Paradise Business Centre

Lot 1, Block 1,
Paradise Valley Second Addition

Buildings 1, 2, 3, & 4

Revision Schedule		
△	Addendum	01/03/2025
△	Addendum	01/14/2025

1 BUILDING # 1 & 2
SERVICE CONNECTIONS DETAIL
1"=10"

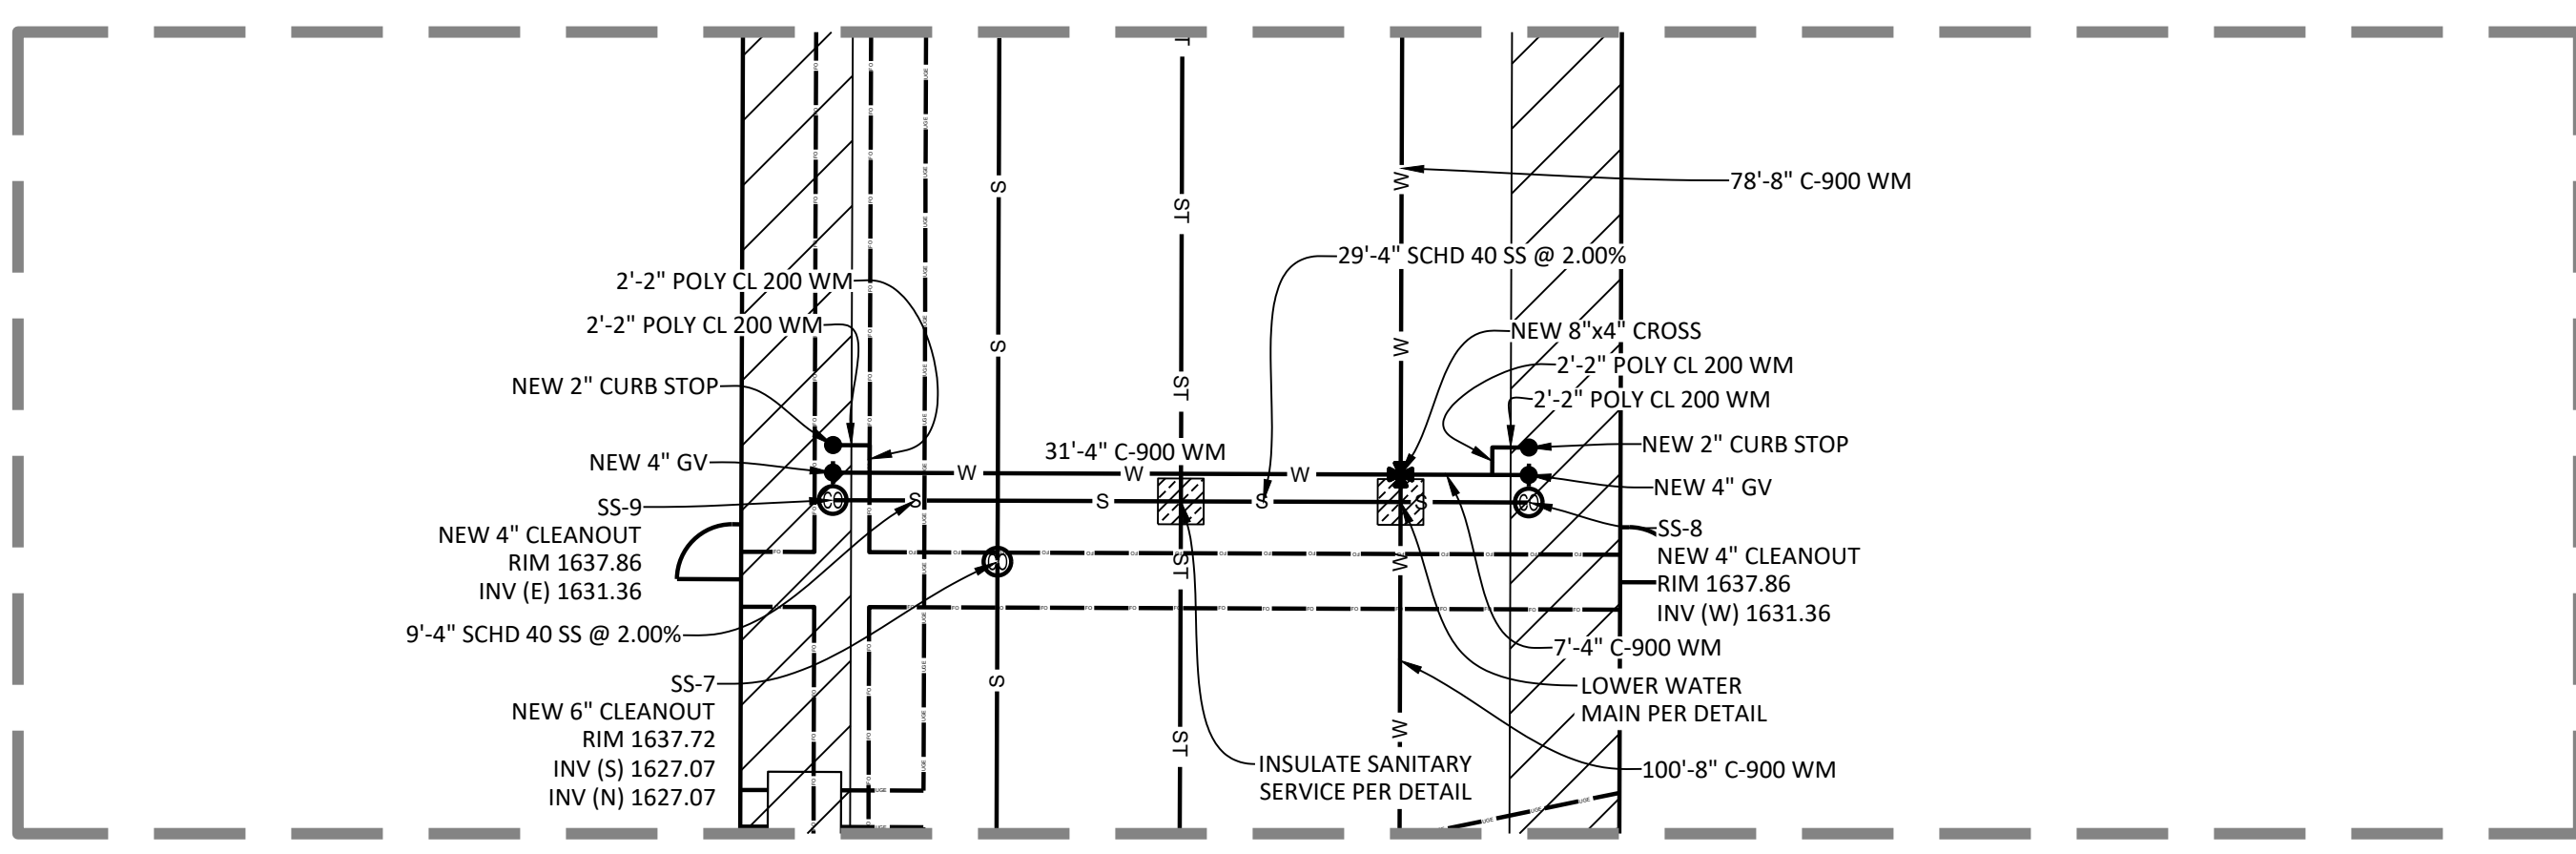
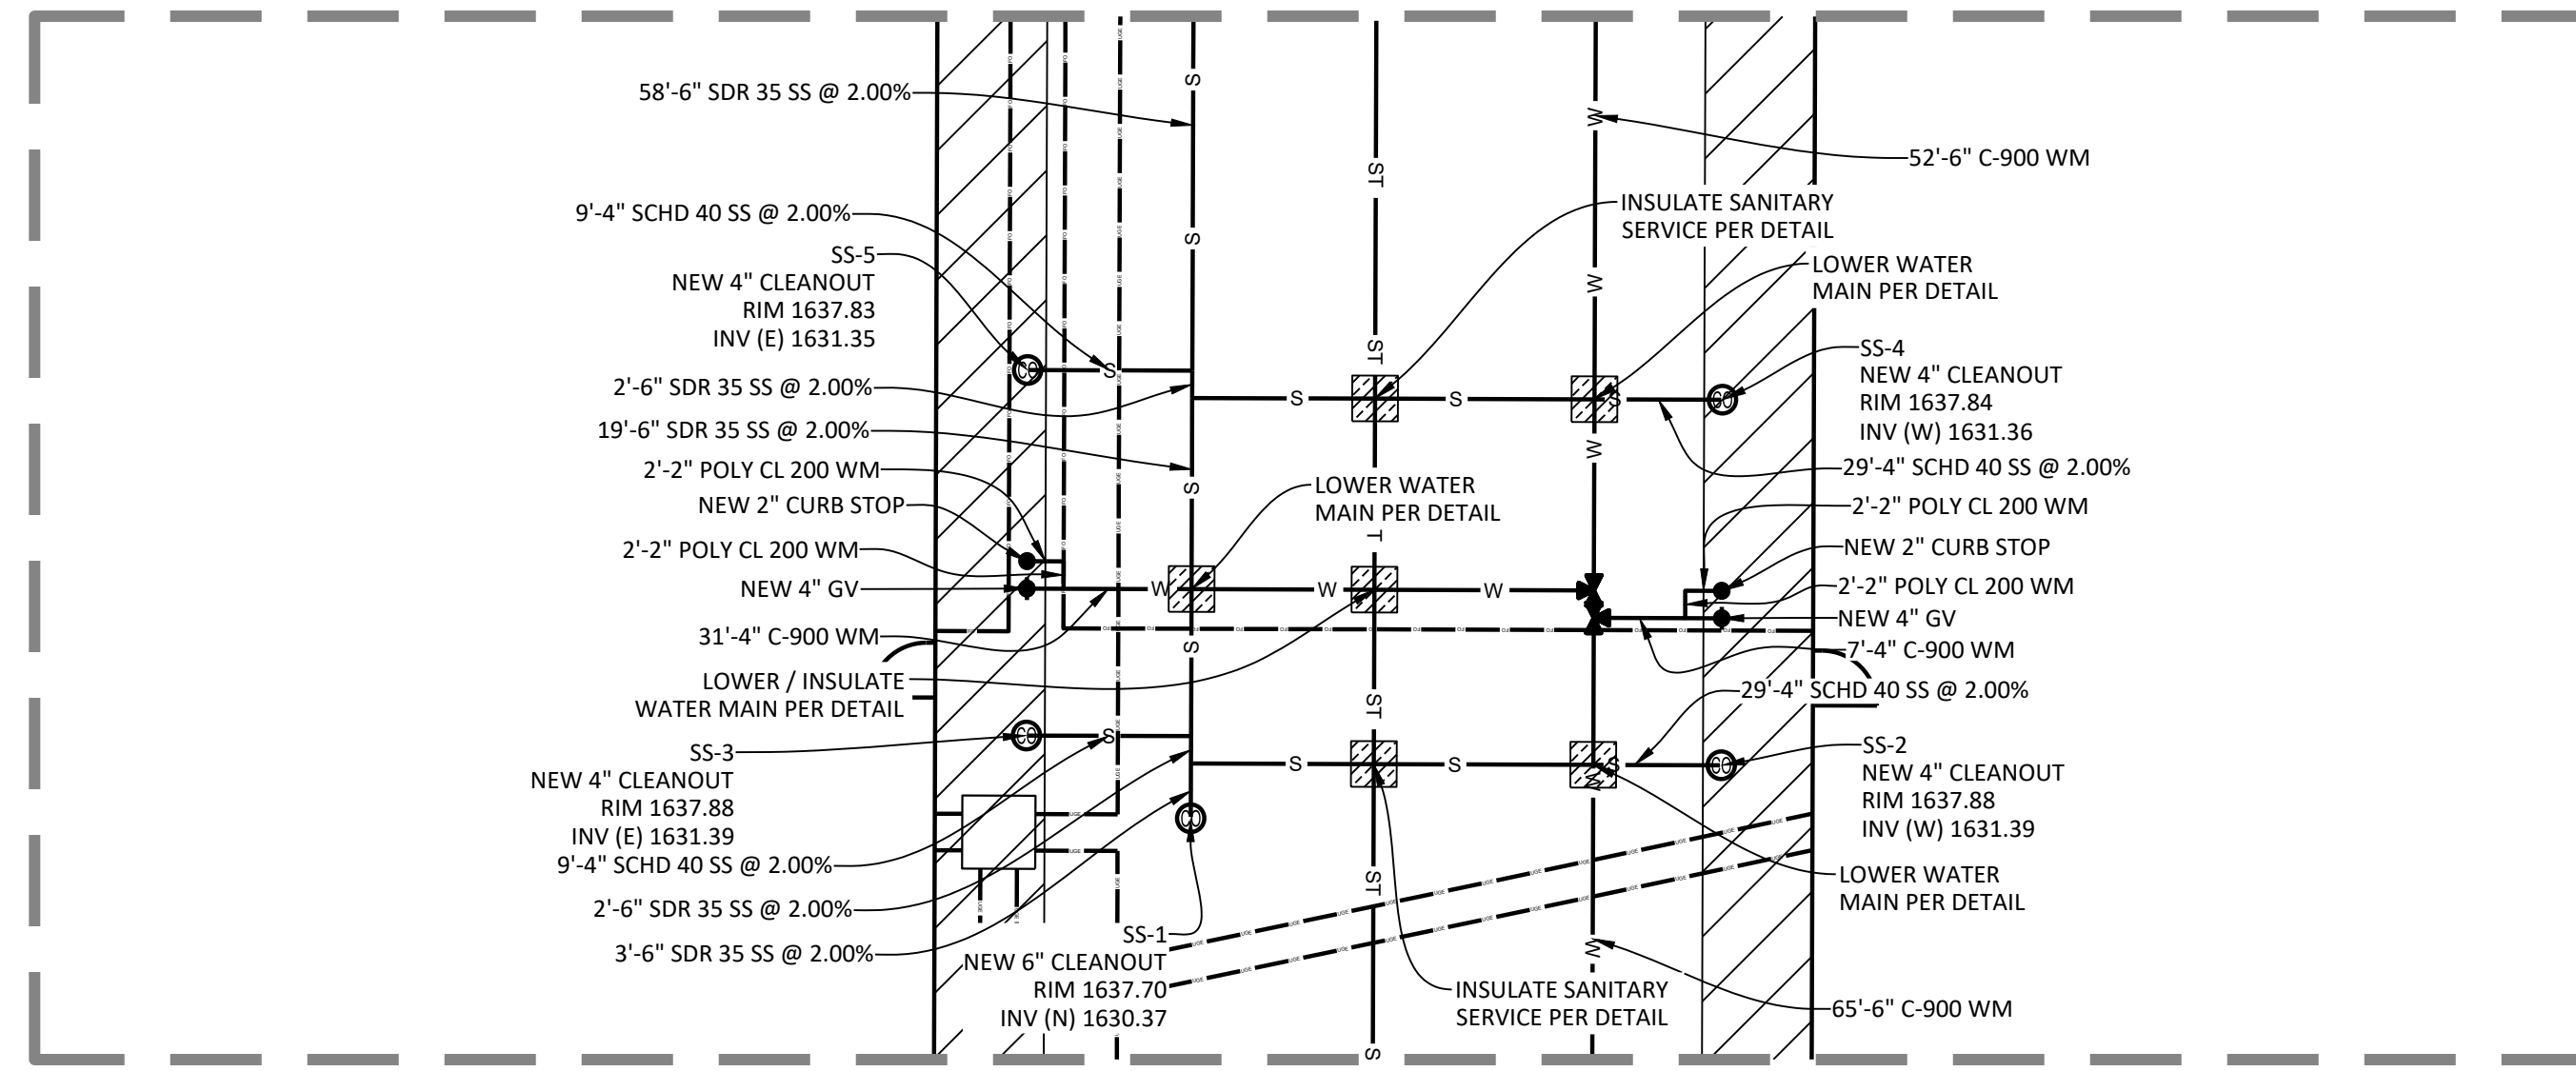
REVISIONS PER CITY COMMENTS
- MODIFY LOCATION OF STORM INLETS PER LAYOUT AND GRADING REVISIONS. UPDATE QUANTITIES.

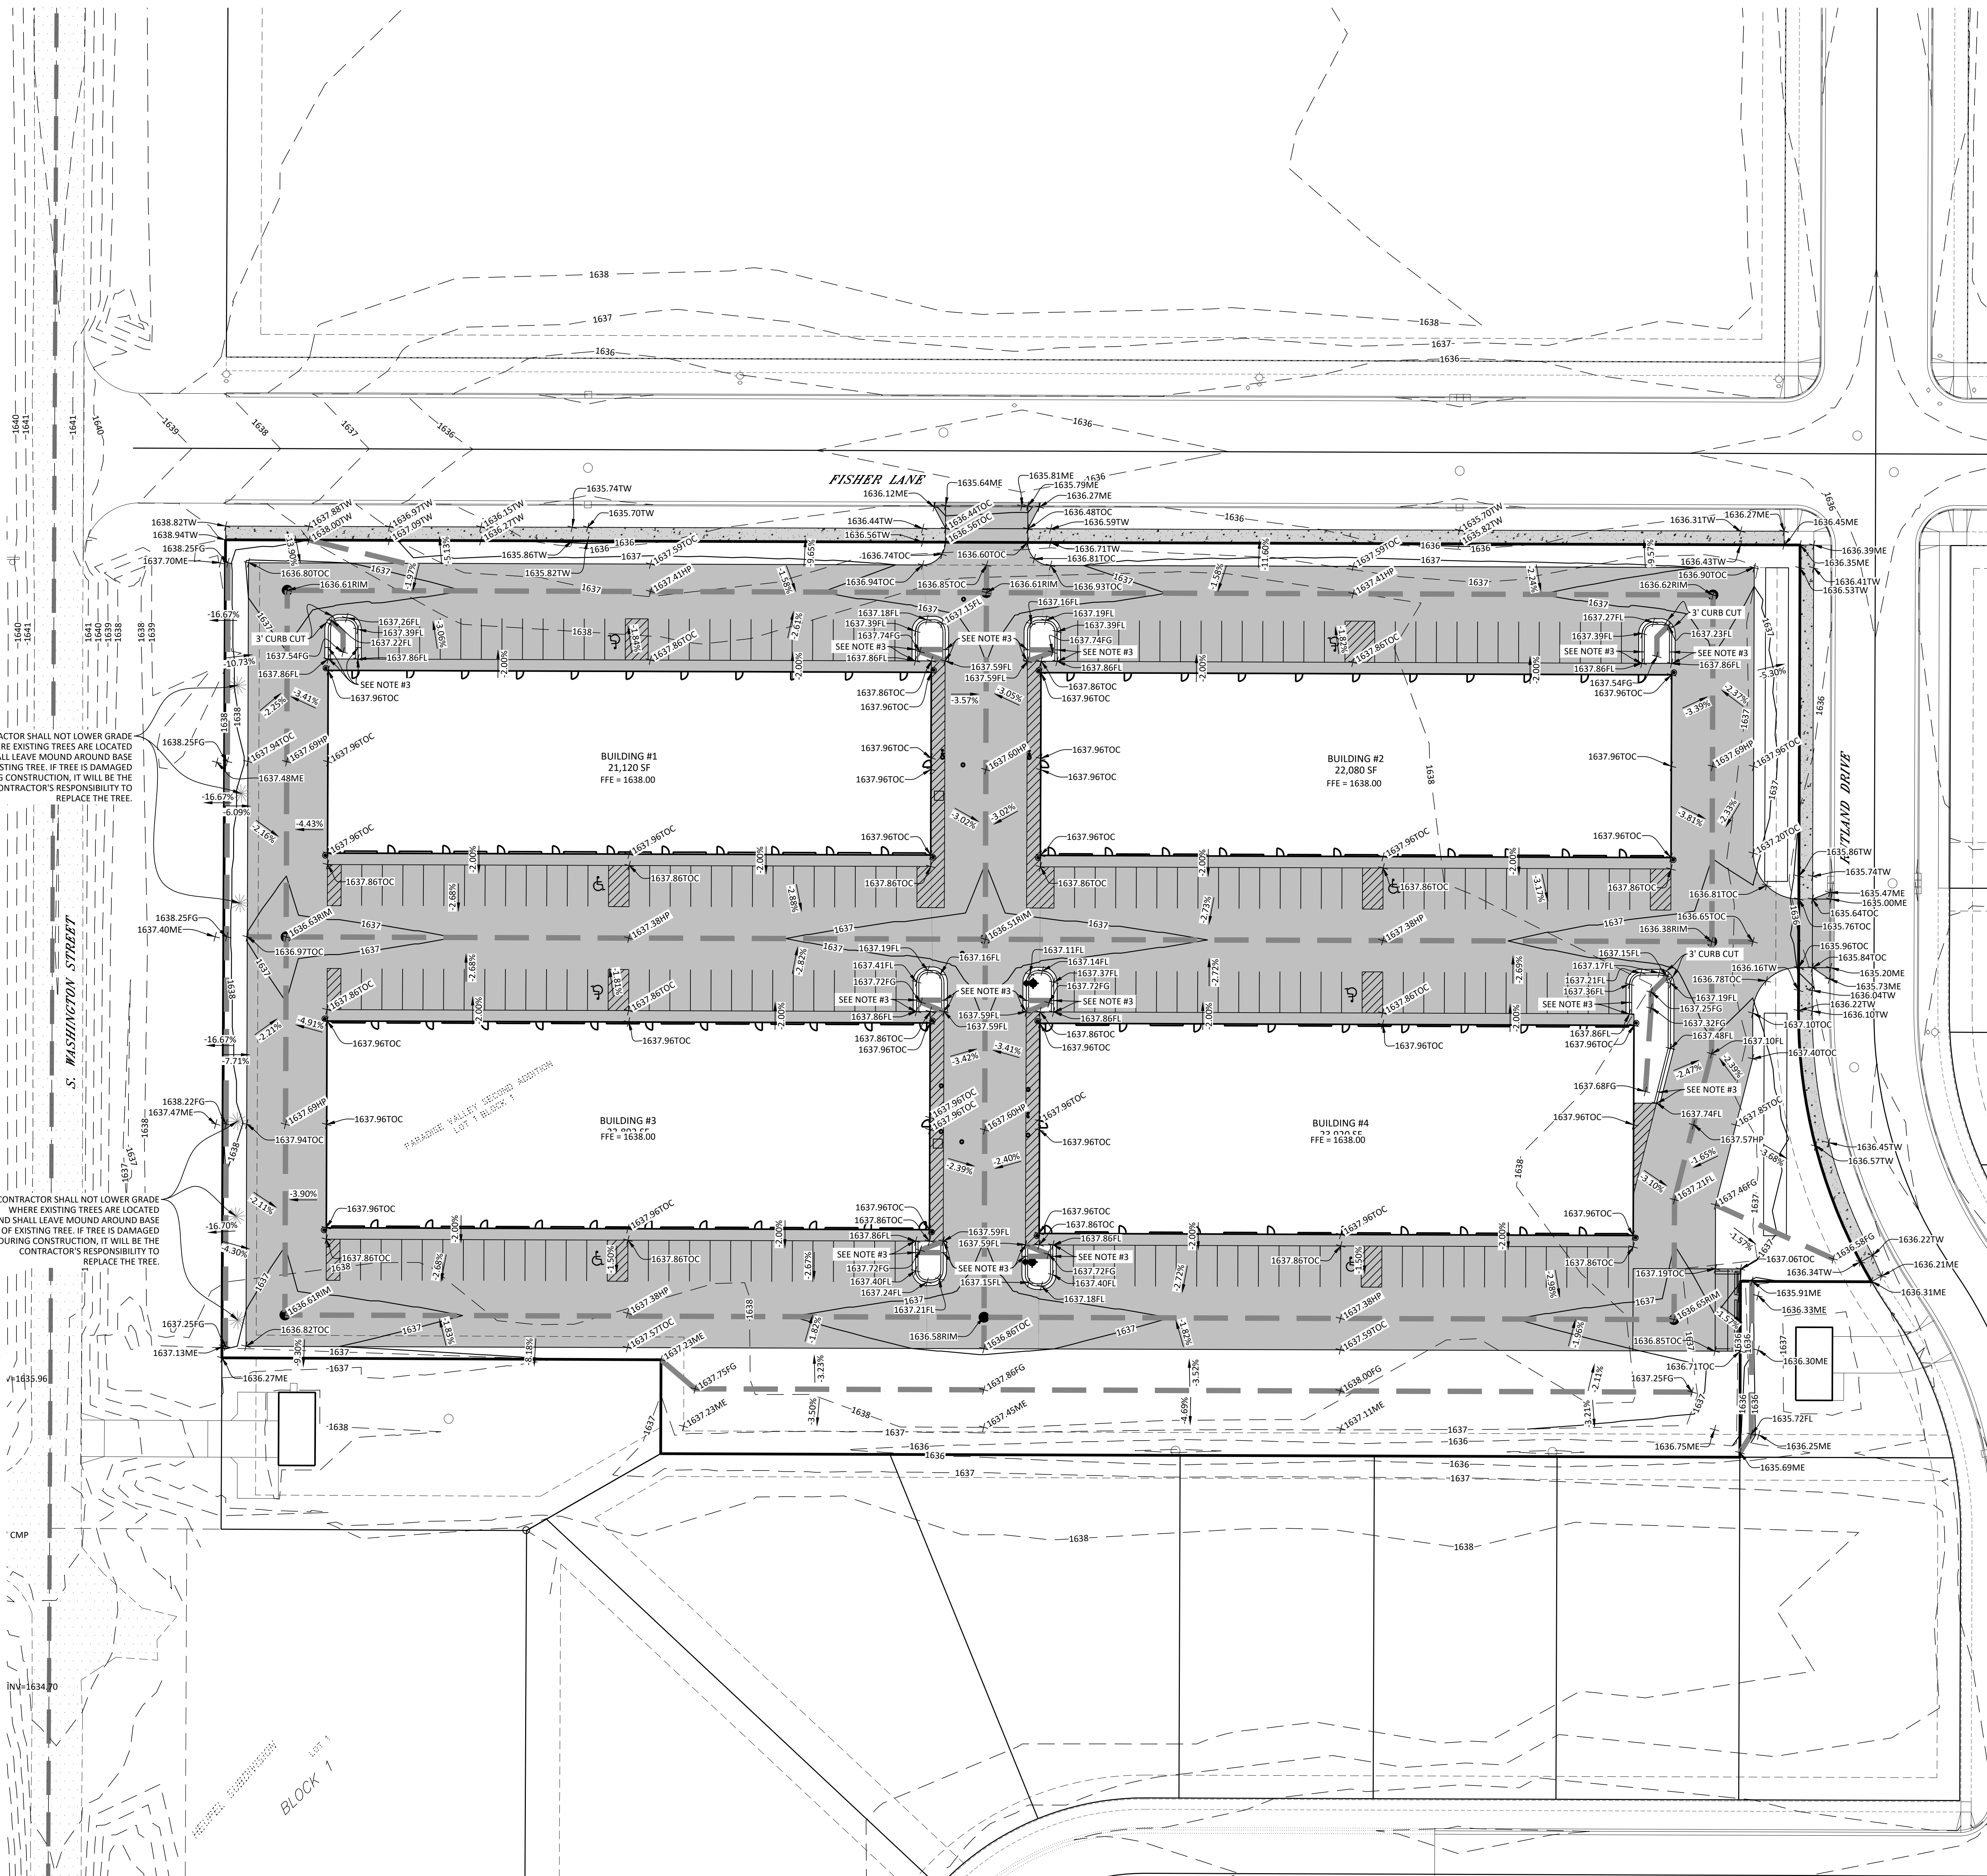
REVISIONS PER CITY PAVING PLANS
 - UPDATE SIDEWALK GRADING IN RUTLAND DRIVE PER CURB AND GUTTER STYLE CHANGES UNDER CITY PAVING PROJECT.

12 SANITARY SEWER DROP CLEANOUT
N.T.S.

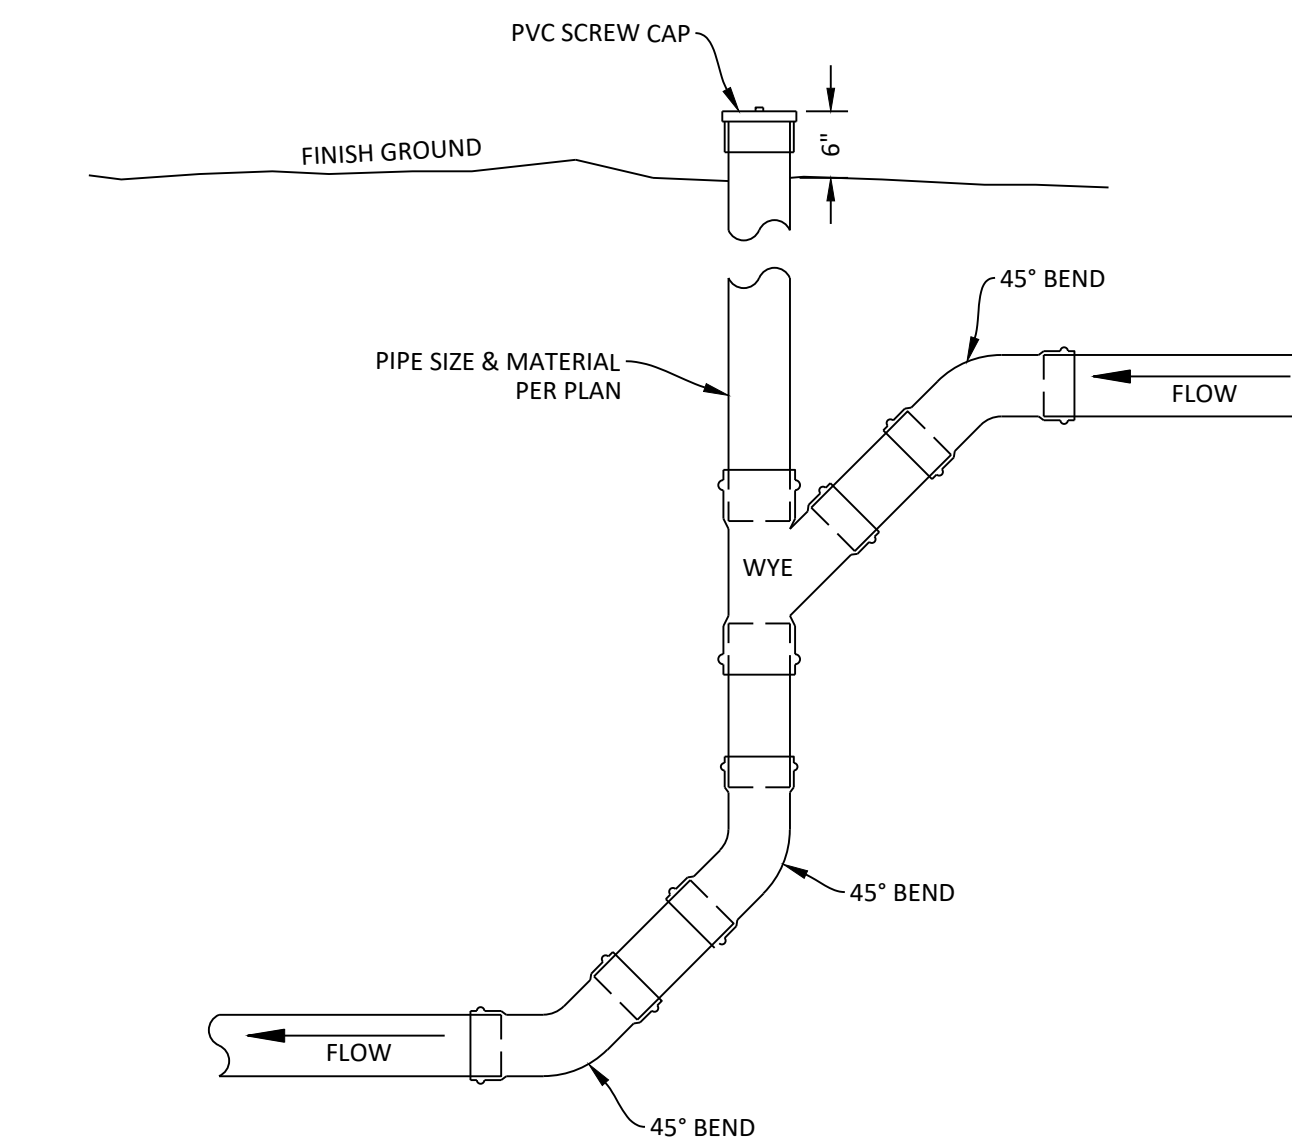
REVISIONS PER CITY COMMENTS
ADD SANITARY DROP CLEANOUT DETAIL.
